ADDENDUM NUMBER 2

ENVIRONMENTAL REPORT

SAGE CREEK COAL PROJECT

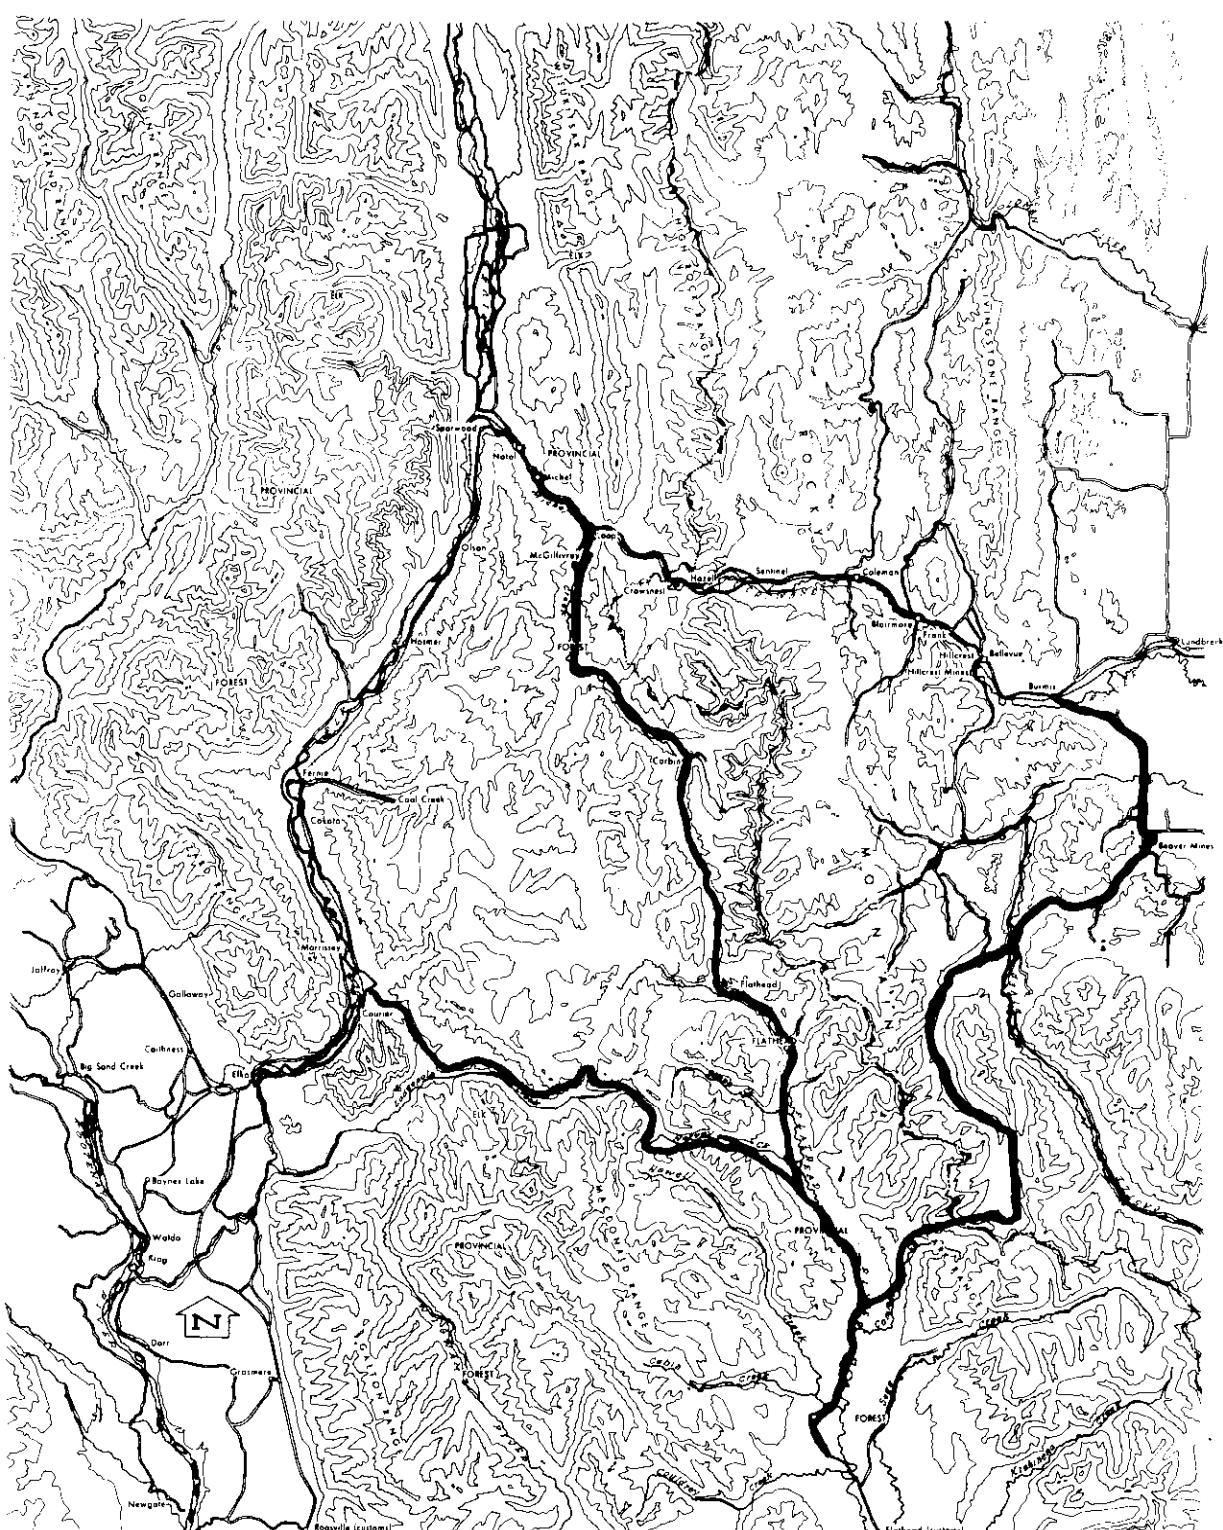
The outline of the preparation plant in the Stage I Report has been changed only slightly. After passing through the rotary breaker, raw coal less than 50 mm in size would be conveyed to the raw coal silos. Refuse from the rotary breaker which is larger than 50 mm would be sent to the refuse stockpile. Once into the preparation plant, material between 50 mm and 19 mm (- 50 mm x + 19 mm) in size would be treated by the heavy media vessel

(H.M. Vessel). The balance of the cleaning plant operation would remain as in the Stage I Report. The change noted above is also shown on the simplified flowsheet (Figure III-2).

FIGURE III-4
TOWNSITE LOCATION MAP
WITH ENVIRONMENTALLY SENSITIVE AREAS

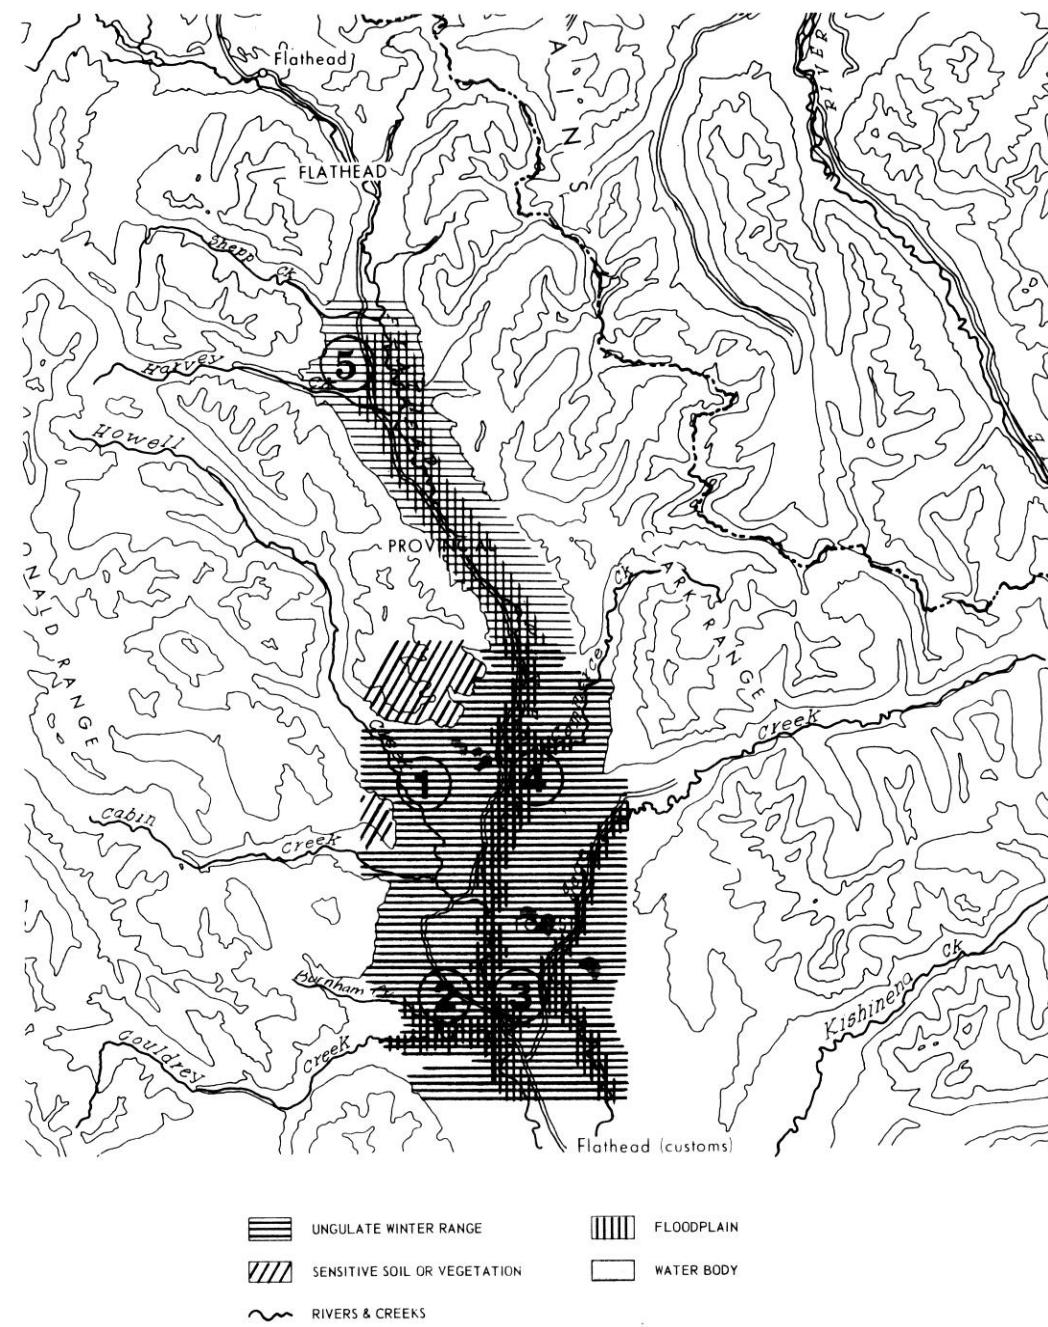
As the project size has been scaled down, so too has the size of the town. The estimated total land requirements would now be about 37 hectares rather than 145. This reduction in size has made it possible to include a fifth alternative which, on consideration, appears more desireable than the earlier choice. The new location is at the junction of the Flathead River and Harvey Creek, about 23 km. north of the proposed minesite. It is farther from the mining operations and the State of Montana but it is closer to Fernie than the previously selected site. There is good potential sun exposure, and other climatological factors should be favourable. In other respects, the basic assumptions used in the original report remain the same. The new location is labelled area 5, and is shown on Figure III-4.

FIGURE IV-1
WATER BALANCE, COAL PREPARATION PLANT

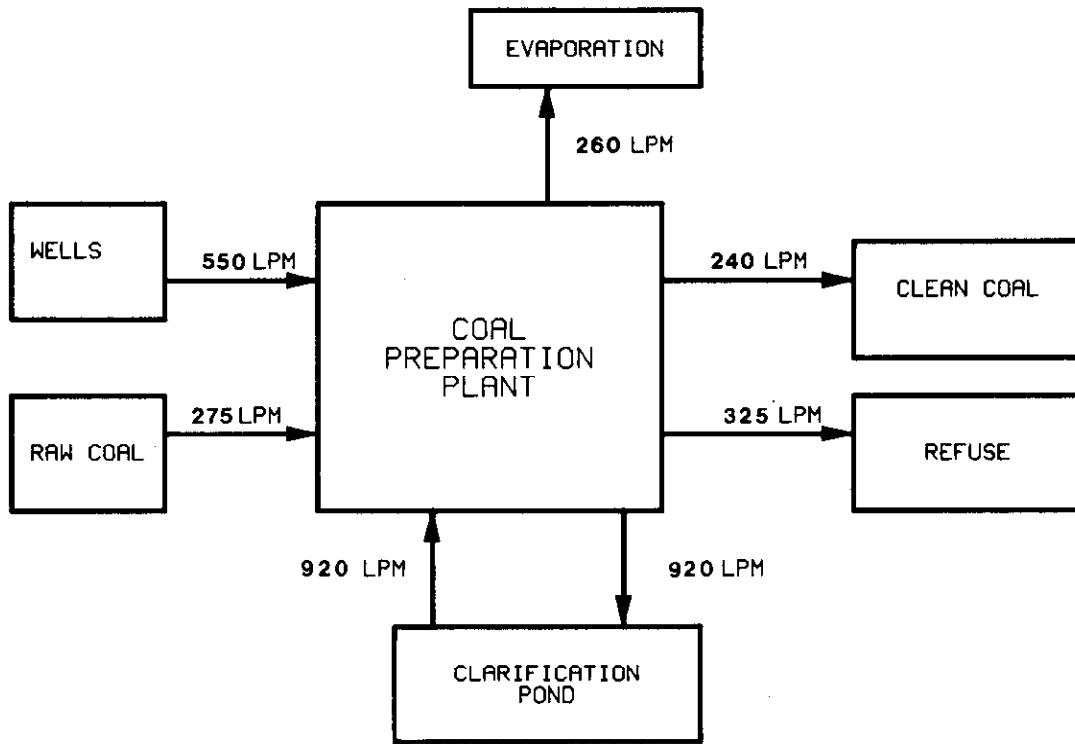
The design of water utilization for the preparation plant and the water source remains the same as in the Stage I Report. The quantities of water, however, have changed. A preliminary water balance is given in Figure IV-1 and the total water requirements are shown in Table IV-3 below.
